Bradley Heights

PROJECT DESCRIPTION
 SITE DEVELOPMENT IMPROVEMENTS, INCLUDING CLEARING, GRADING, RETAINING WALLS, PARKING LOT, STORM DRAINAGE, SANITARY SEWER MAIN, WATER MAIN FOR 238 UNIT MULTI-FAMILY DEVELOPMENT.

SITE ADDRESS:
 202 27TH AVE SE

Retaining Wall B Plan
 Bradley Heights
 Timberlane Partners
 1816 11th Ave Unit C
 Seattle, WA 98122
 Phone 206.886.0326
 Fax jordan@timberlanepartners.com

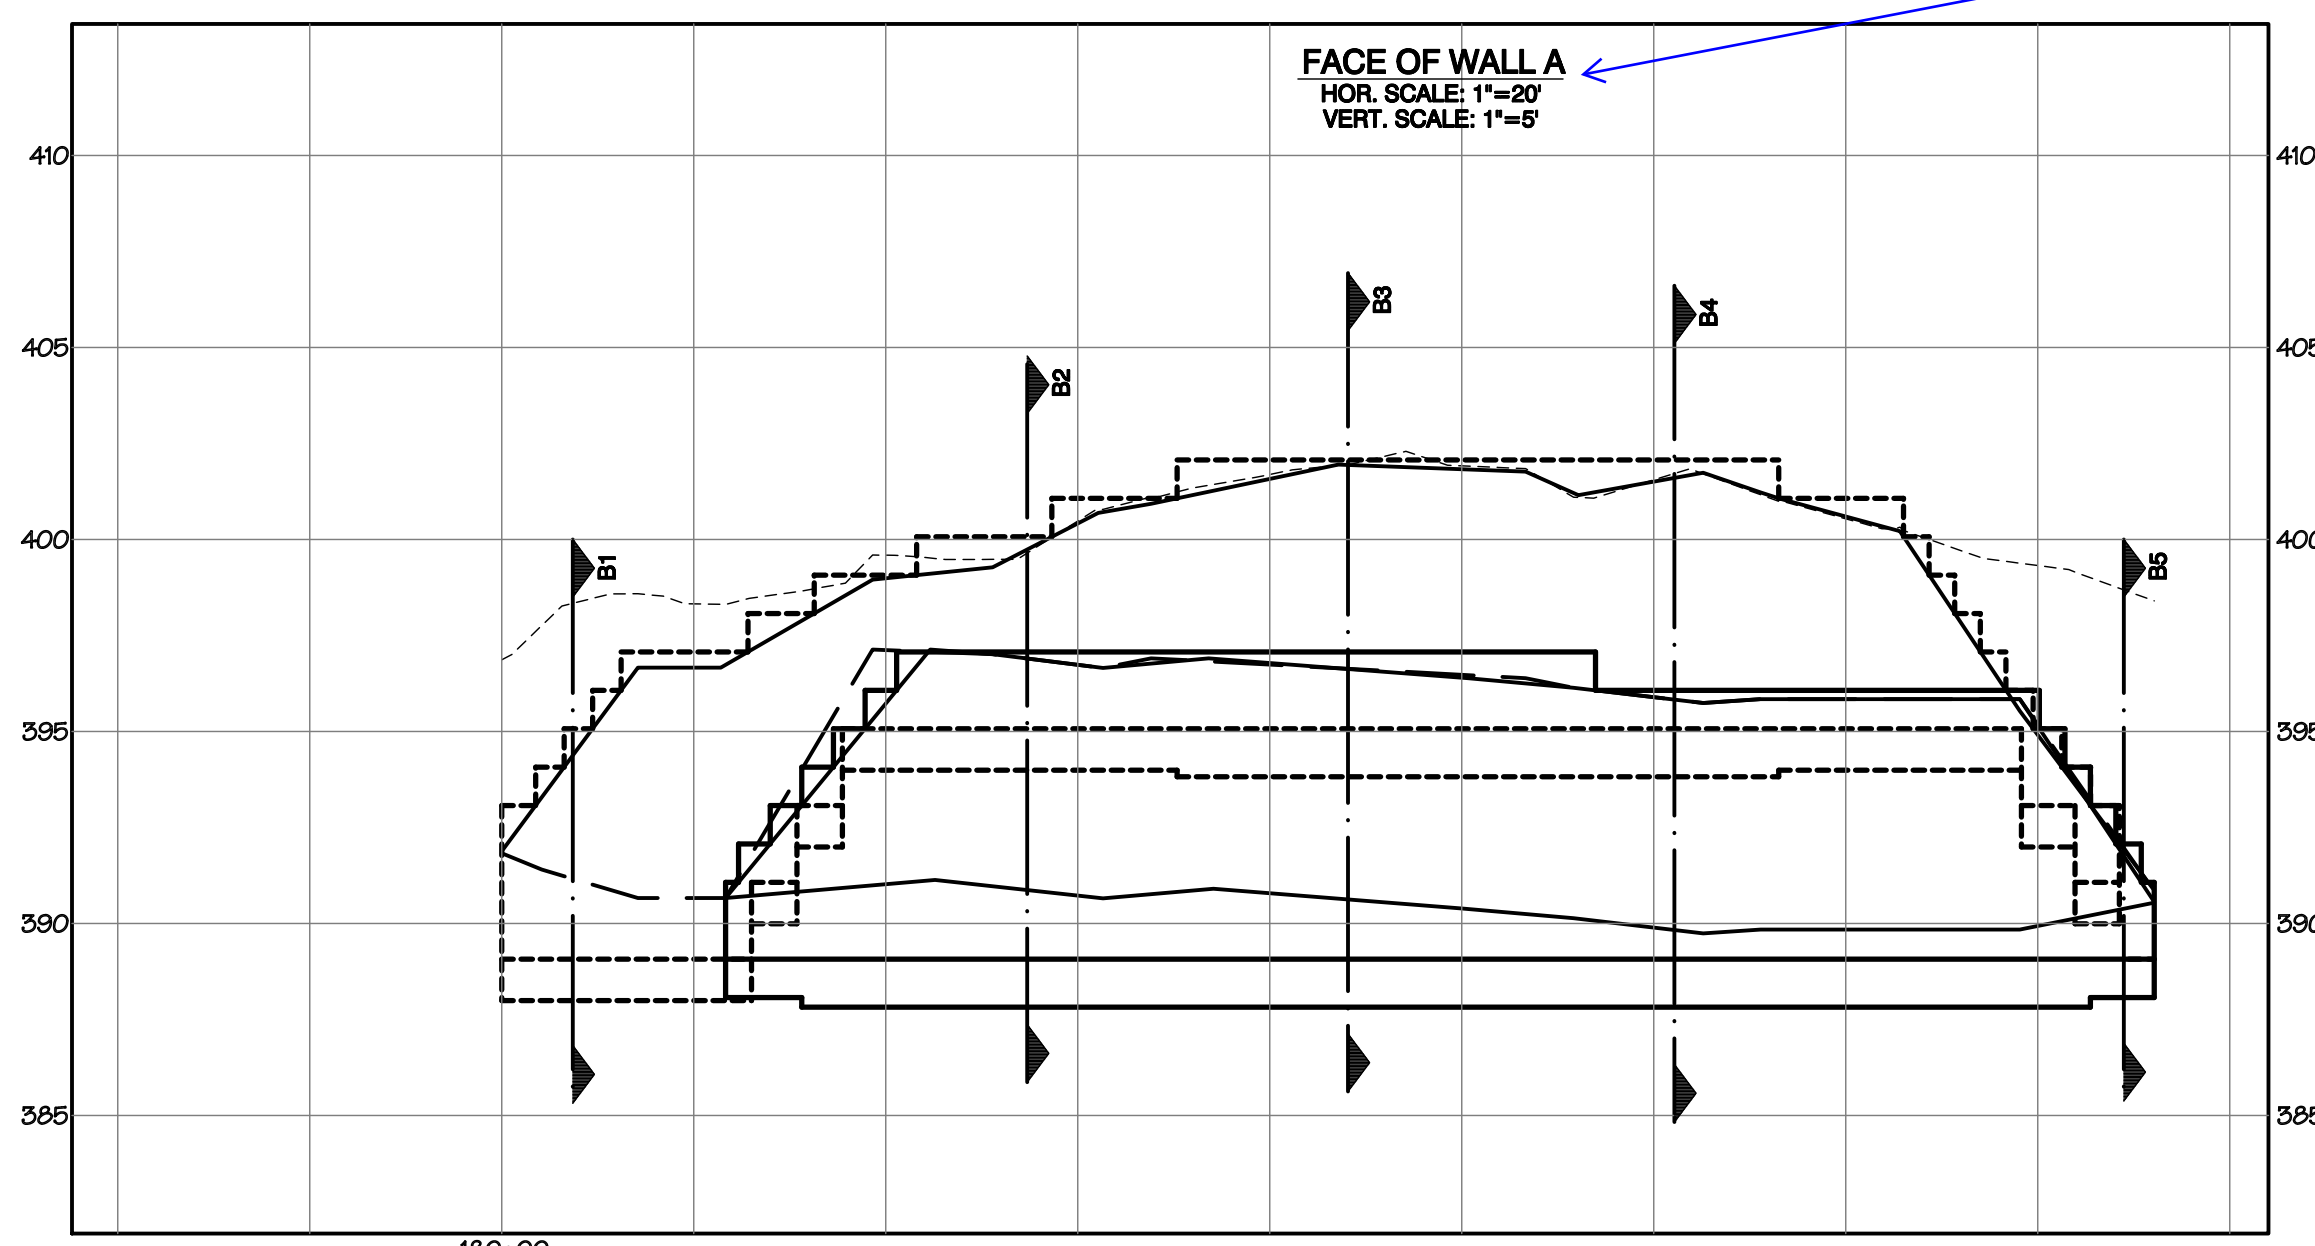
Remove incorrect north arrow. [CIVIL PLANS, Sheet G14]

B1 and B2. [CIVIL PLANS, Sheet G-14]

27th Ave SE Plan & Profile

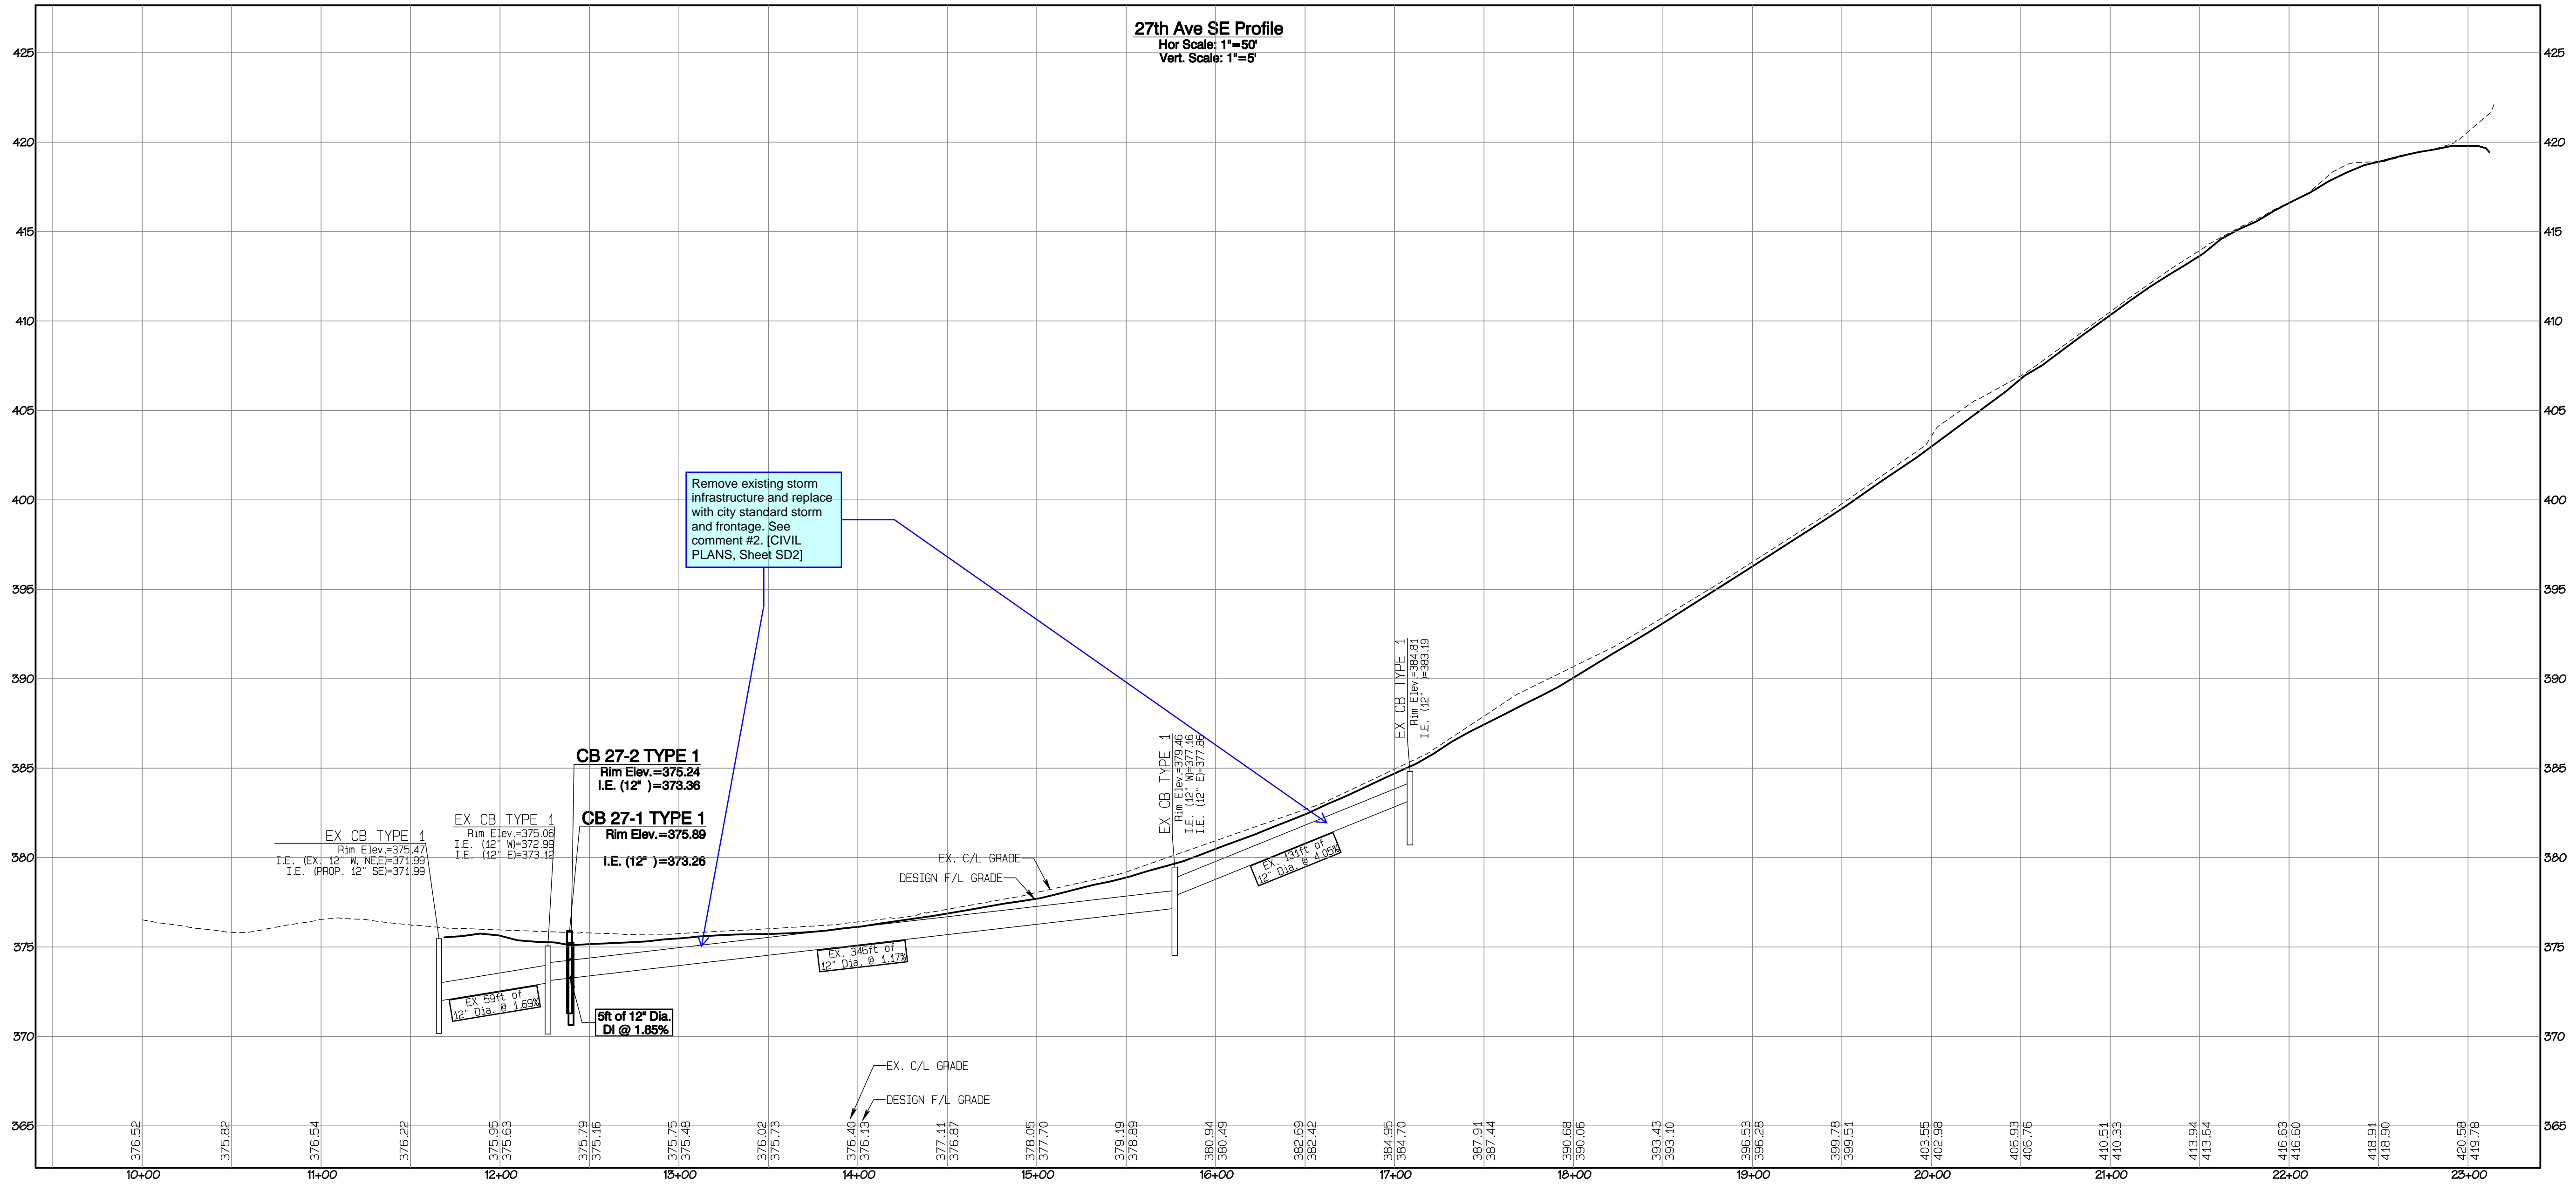
Plan view is 1"=50'
[CIVIL PLANS, Sheet
SD2]

Show overhead powerlines and poles to identify possible conflicts with the new frontage. [CIVIL PLANS, Sheet SD2]

Remove existing storm infrastructure and replace with city standard storm and frontage. See comment #2. [CIVIL PLANS, Sheet SD2]
